Our Ref: SK/7923/jj

23 November, 2010

# RE: PROPOSED PREFORM INJECTION MOULDING PLANT COCA COLA AMATIL SITE, EASTERN CREEK

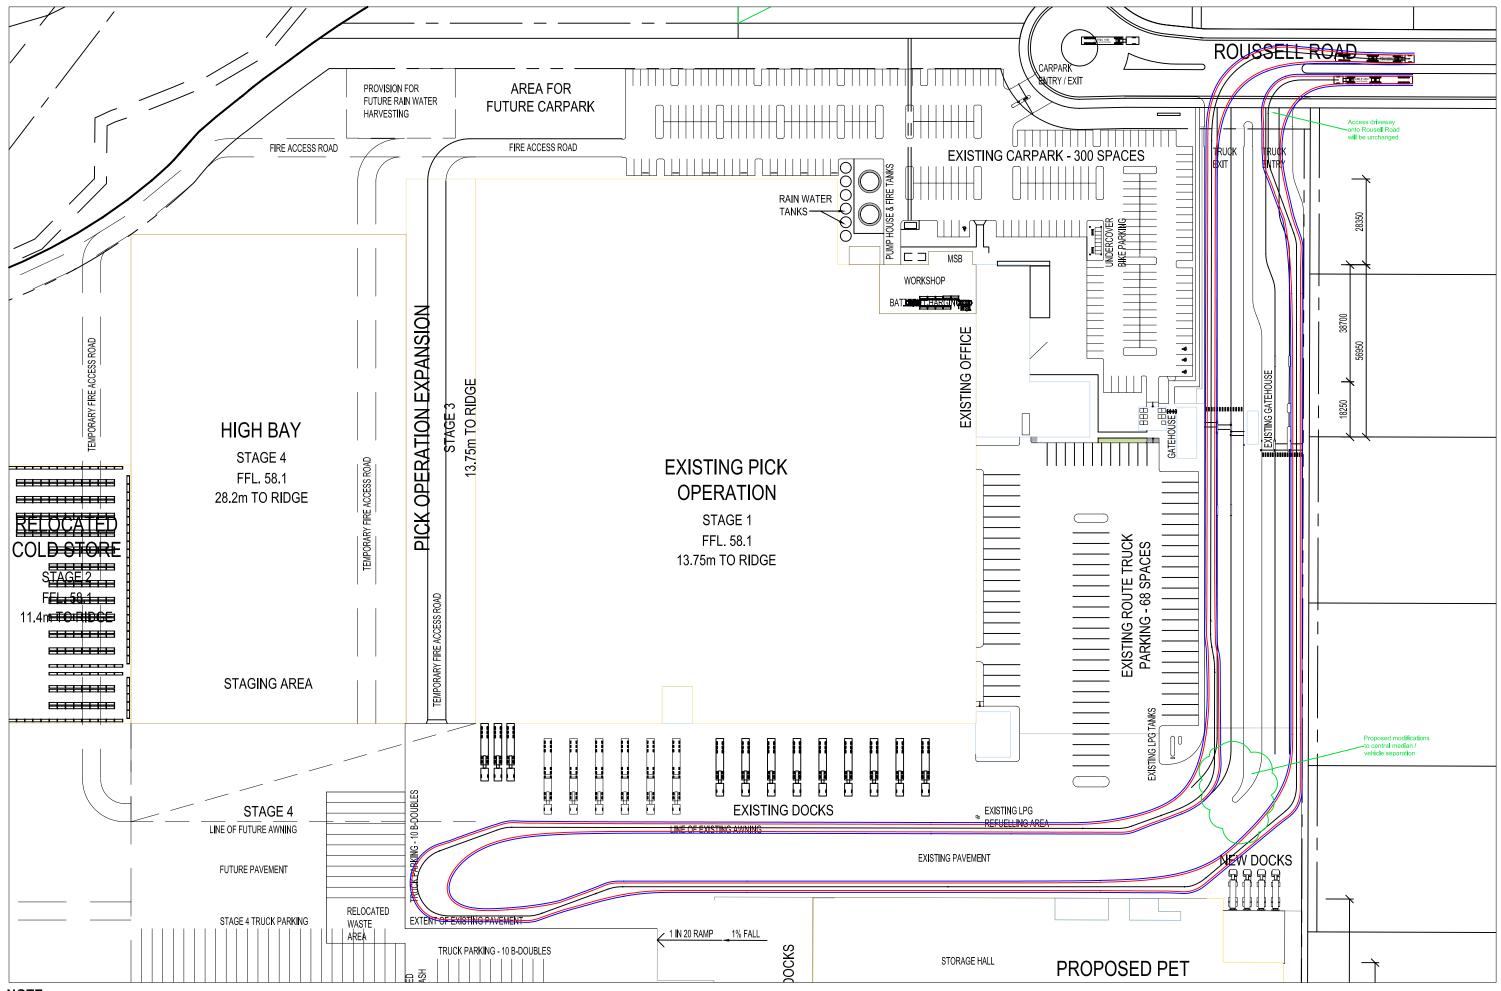
- P14 of the traffic assessment states 'the site access arrangements remain unchanged' yet p12 of the EA states there will be 'minor reconfiguration of vehicle access arrangements at the southern end of truck entry'; p2 of the waste assessment also states that there will be a reconfiguration of the existing access arrangements. Please clarify.

- 13. The minor reconfiguration of the vehicle access arrangements, as described on p12 of the EA report, refers to changes to traffic circulation at the southern end of the internal access road, located adjacent to the eastern boundary of the site, as shown on Figure 1. The proposed changes include a shortening of the central median/vehicle separation, in order to provide for vehicle swept paths and access to future loading docks. Access arrangements at the access driveway onto Roussell Road will remain unchanged.

12.5m LARGE RIGID VEHICLE SWEPT PATHS

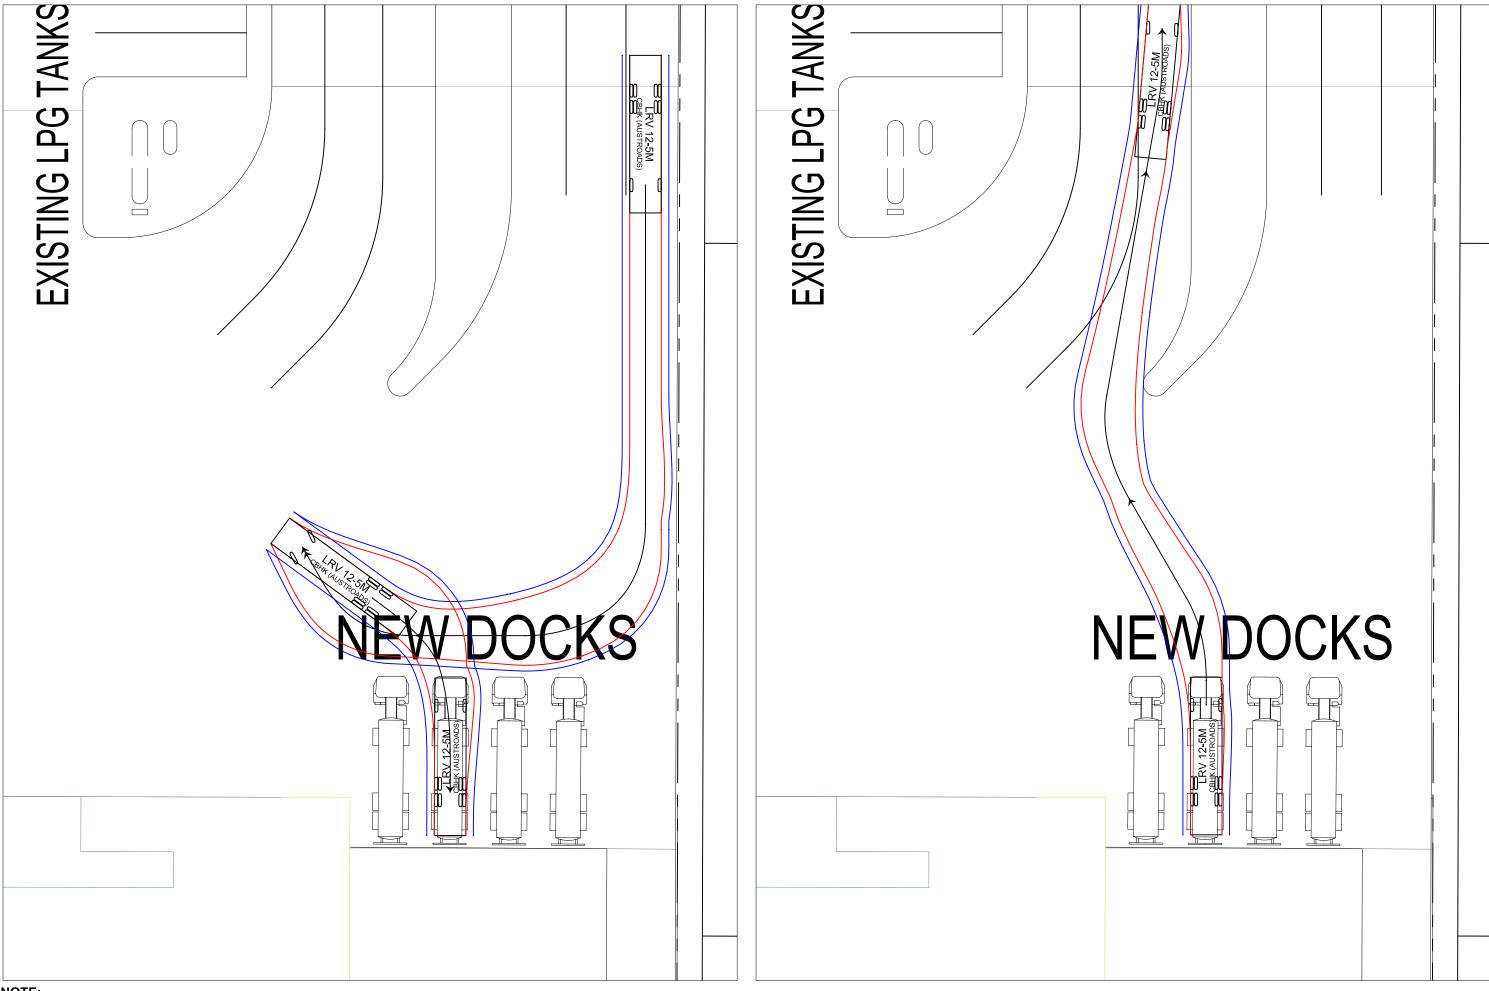
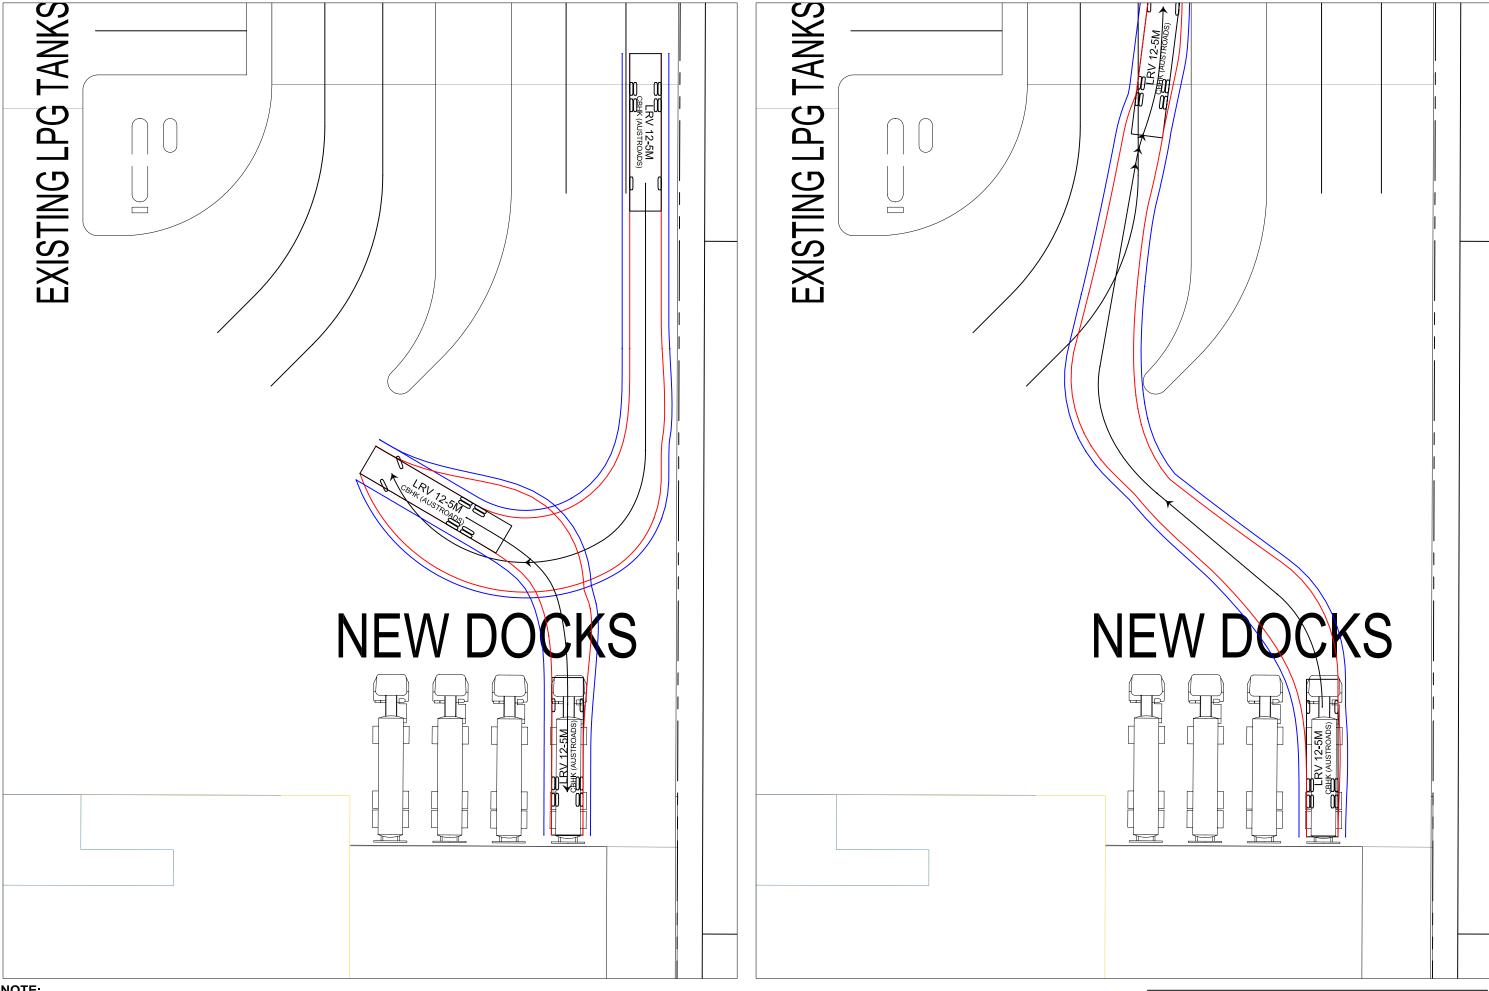
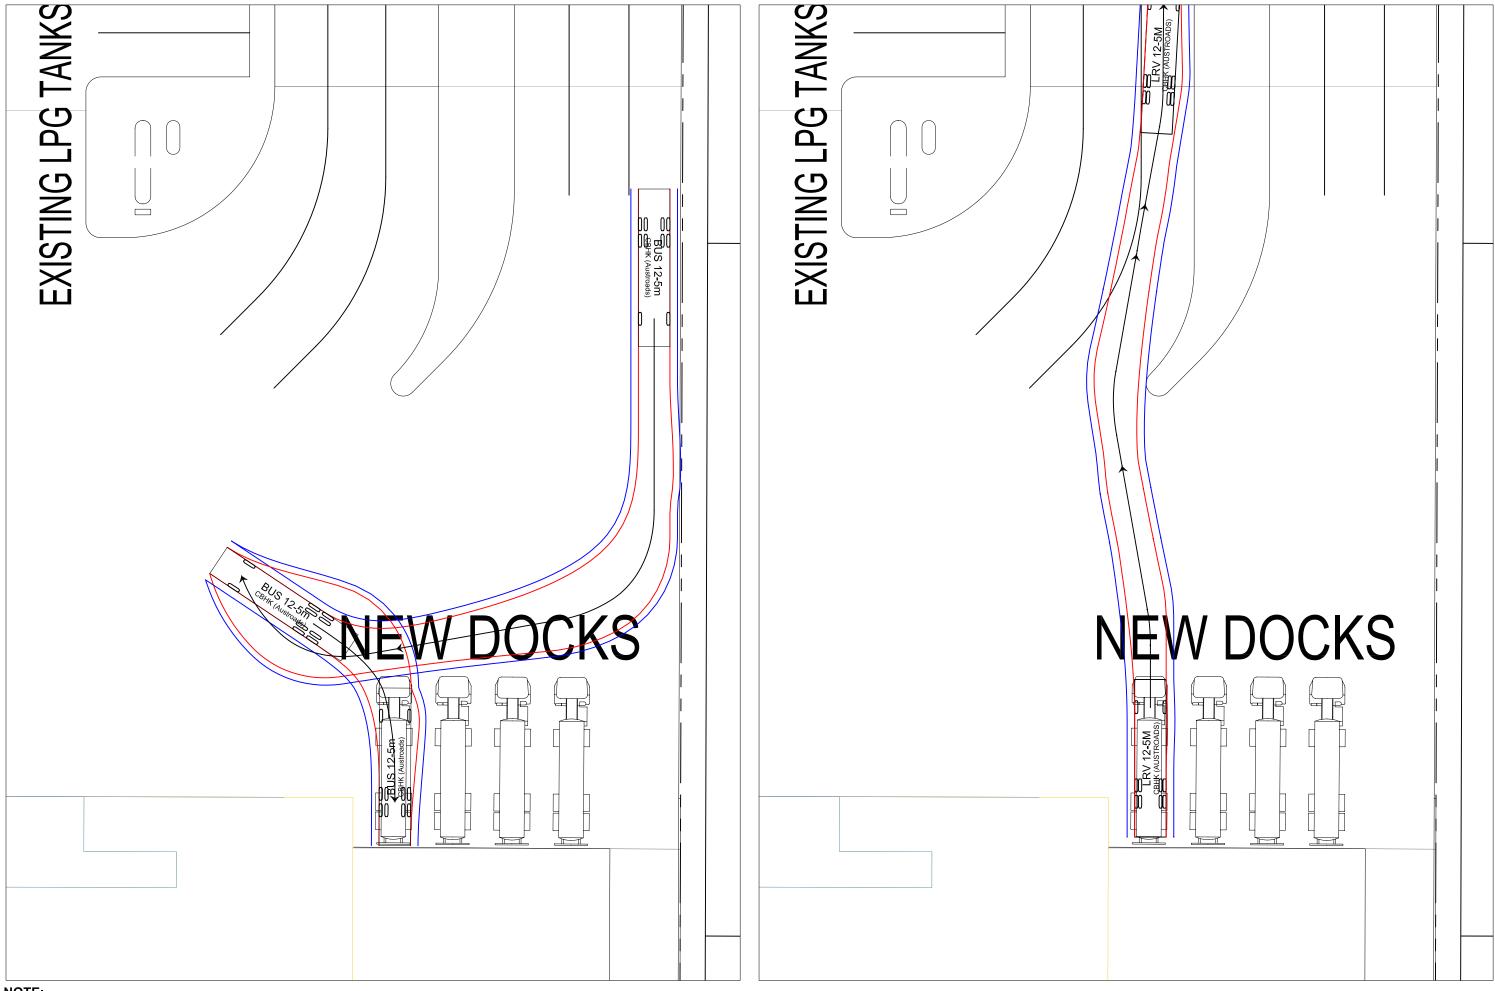
- P15 of the traffic assessment states the 'Our assessment found that the proposed modified truck circulation and manoeuvring zone for the existing distribution centre and for the proposed preform injection moulding plant is considered appropriate to comfortably cater for the expected service vehicle activity, of up to five trucks per hour two-way at peak times.' Please provide a more detailed discussion, including figures, of the modified truck circulation paths.

- 19. Figures 20 to 25 show the swept paths of trucks accessing the proposed new preform injection moulding plant. The loading docks located at the western end of the facility have been designed to cater for articulated vehicles and B-doubles. The loading docks located at the north-eastern corner of the new facility have been designed to cater for large rigid trucks.

- 20. As shown on the attached swept paths (Figures 20 to 25) the proposed loading dock arrangements from the new facility are considered appropriate and have been provided in accordance with the Australian Standard AS2890.2-2002.
